## SAFETY ADVISORY # 24-459

### Helux Pin Box Torque

**Fig. 1**

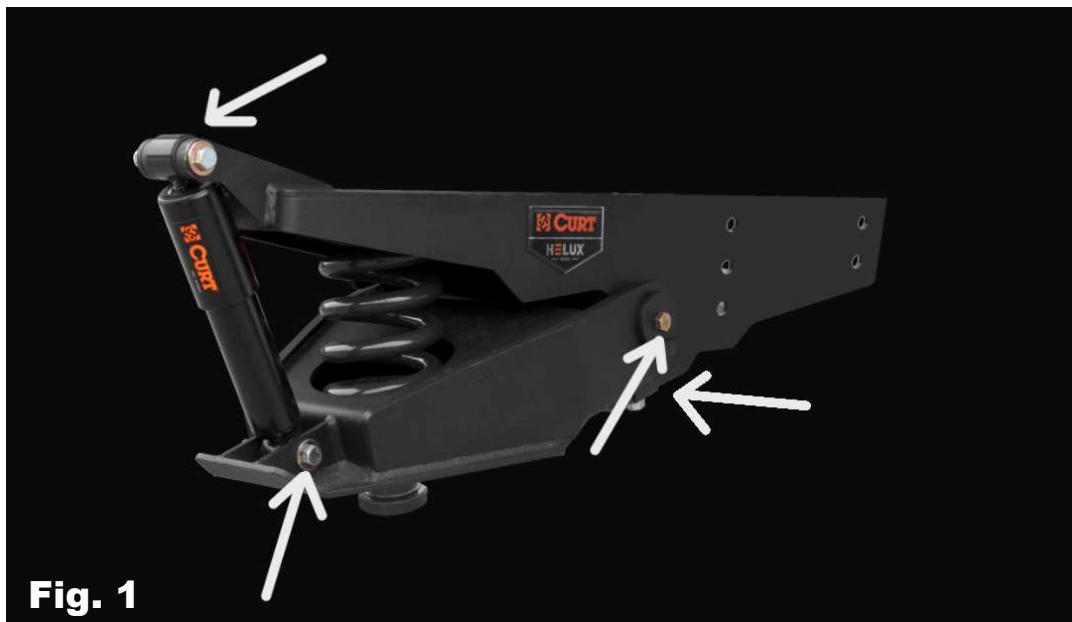
The remedy is to properly torque the fasteners on the CURT Helux Pin Box, see Figure 1.

**REPAIR INSTRUCTIONS****Fig. 2****Step 1**

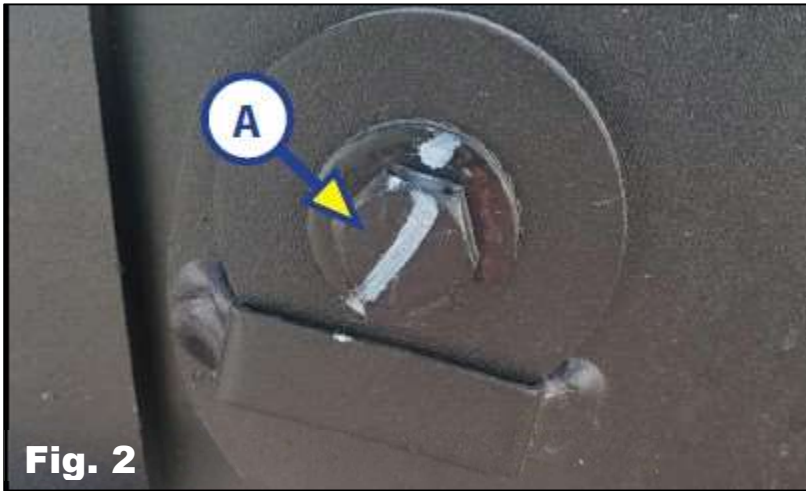
Tighten the Curbside Pivot Bolt Figure 2 to 120 ft-lb. and repeat for the Roadside Pivot Bolt. (not shown).

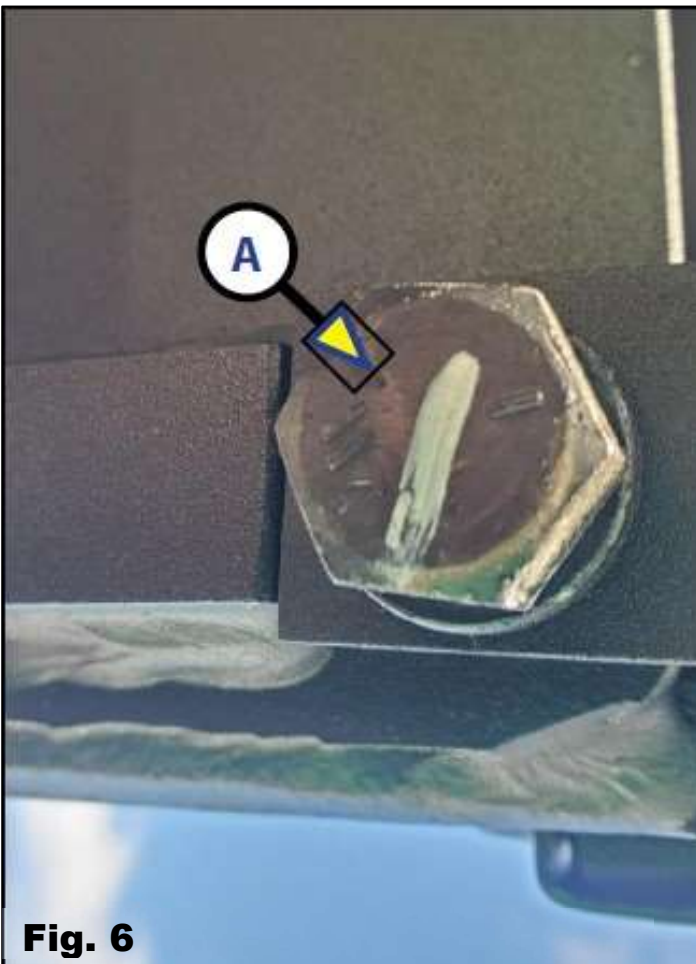
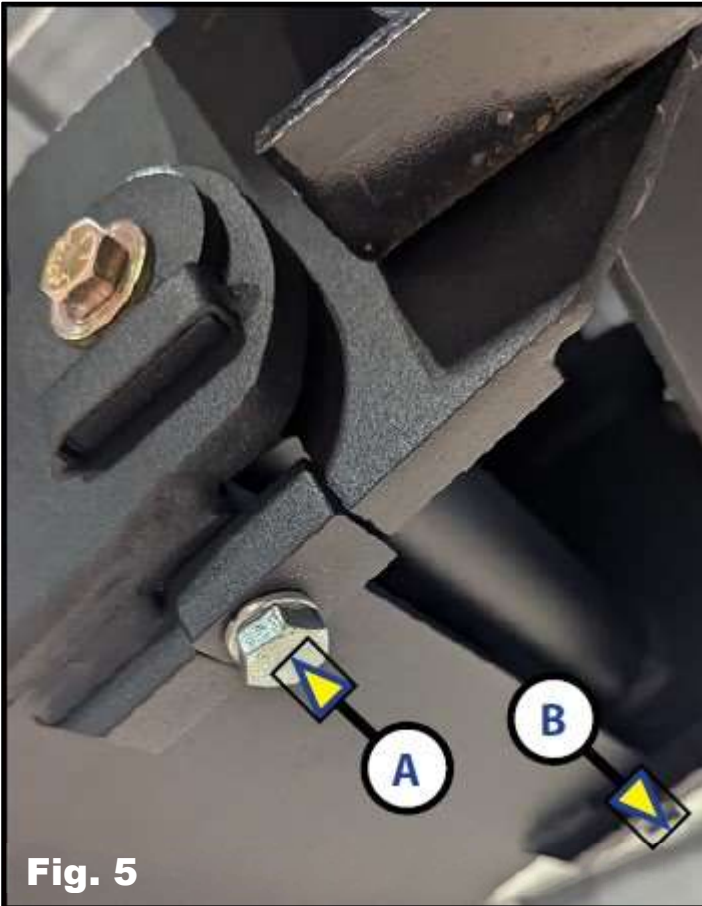
Tighten the Roadside Stop Bolt (Figure 5) to 75 ft-lb.

Repeat for the Curbside Stop Bolt A & B.

**NOTE:** Stop Bolt locations are found on the underside of the pin box (Figures 5 & 6 bolts A & B).
